| This ASB revises ASB-912-061UL dated 26 May 2012

ALERT SERVICE BULLETIN

Replacement of the pressure side fuel hose at fuel pump part no. 893114 for ROTAX® Engine Type 912 (Series)

ATA System: 73-00-00 Fuel system

Fig. 1
Fuel pump

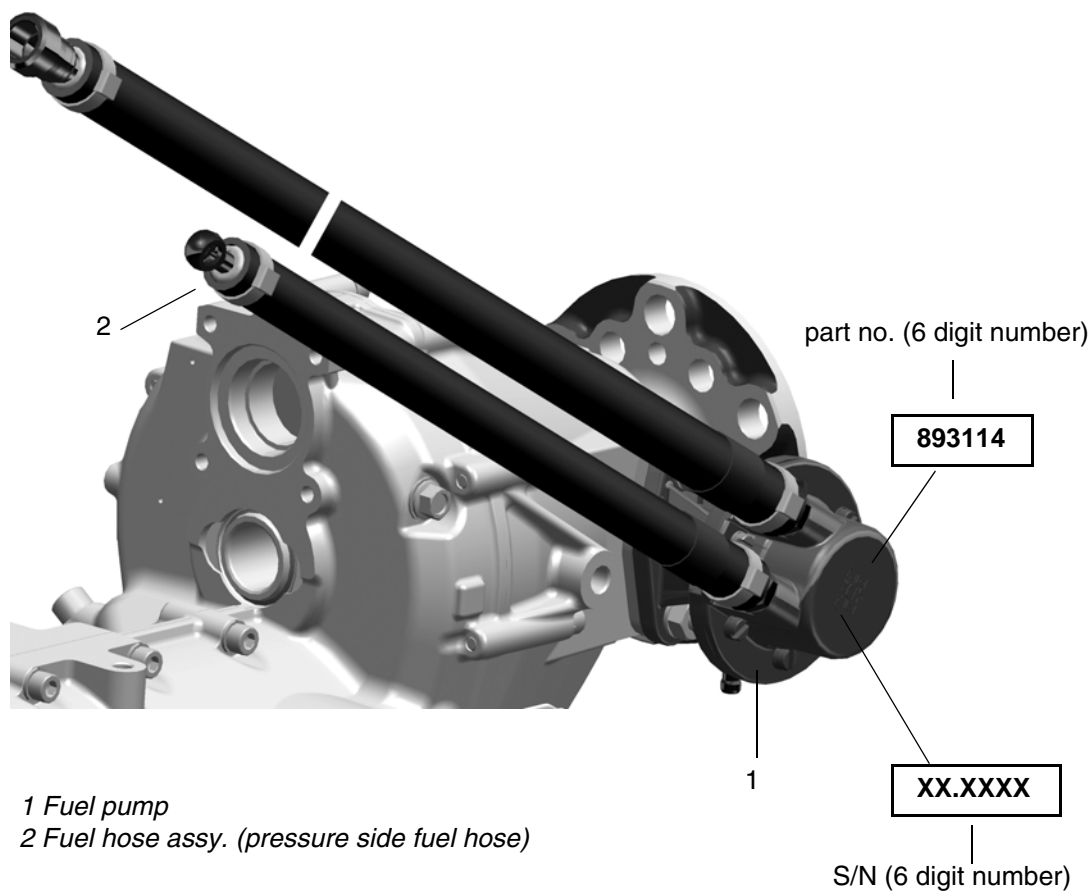
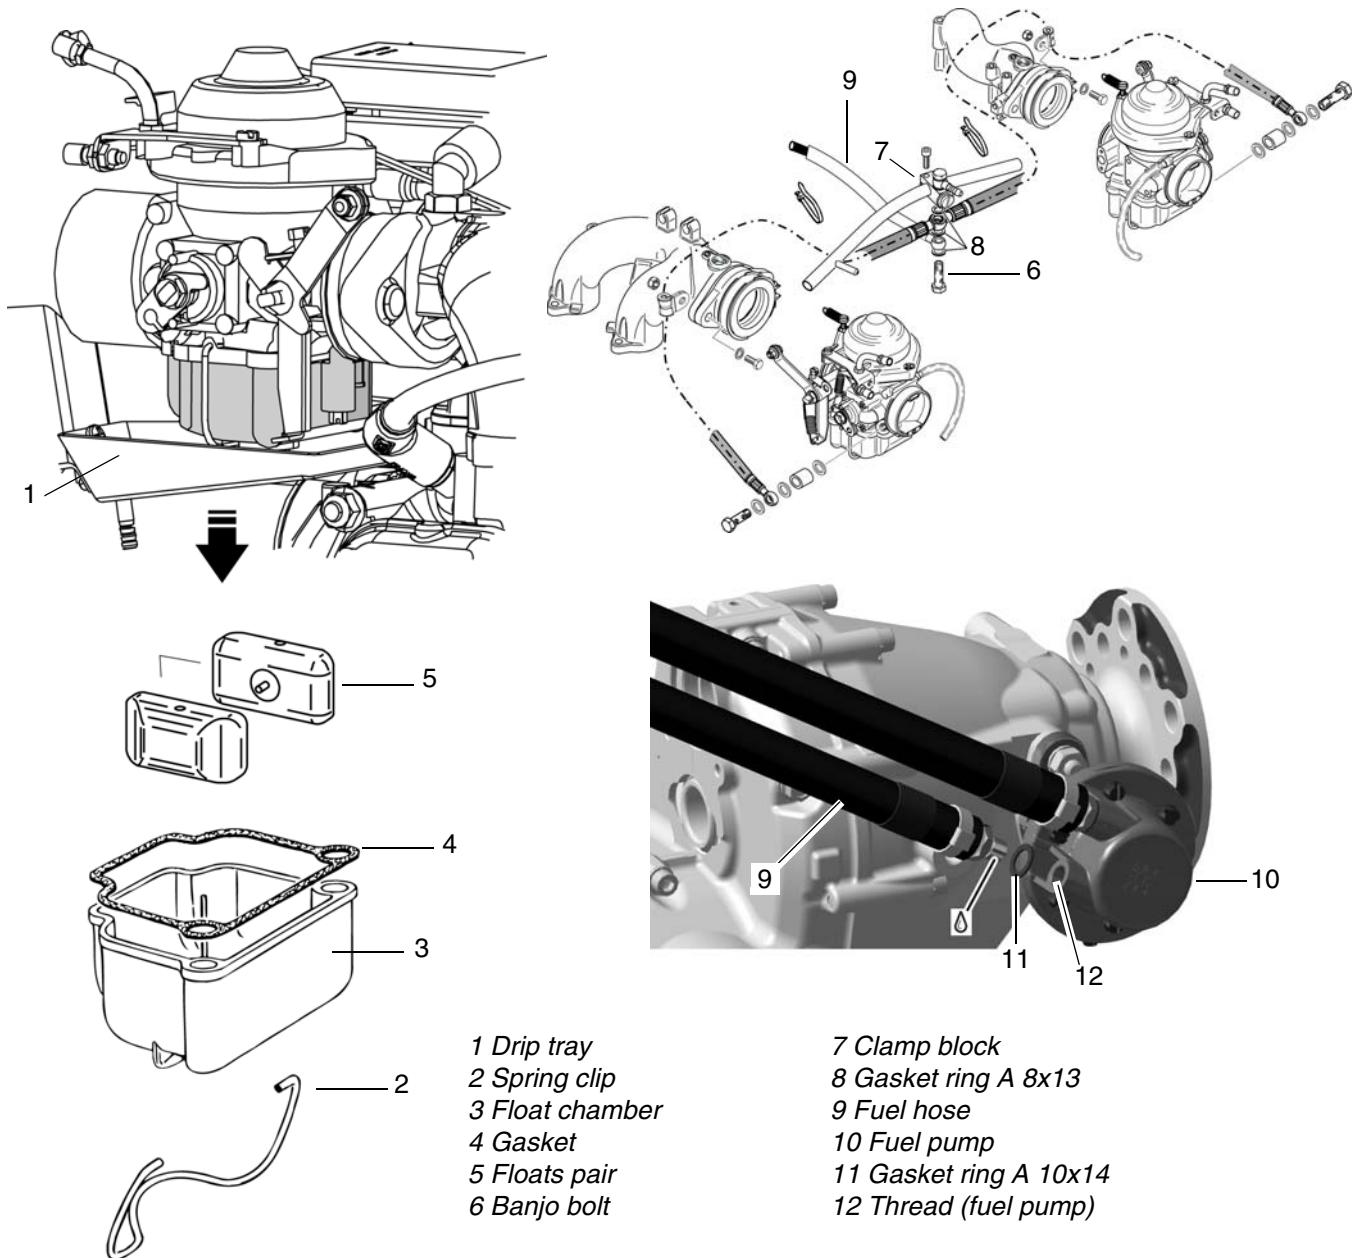
if they are equipped with the genuine ROTAX® fuel pump part no. 893114.
See [Fig. 1](#)

Due to variations in the manufacturing of the fuel hose, rubber particles may become detached. These particles can interfere or suppress the fuel mixture in the carburetor. This disturbance in the fuel mixture may lead to rough engine operation, engine misfire and can cause an engine shut down.
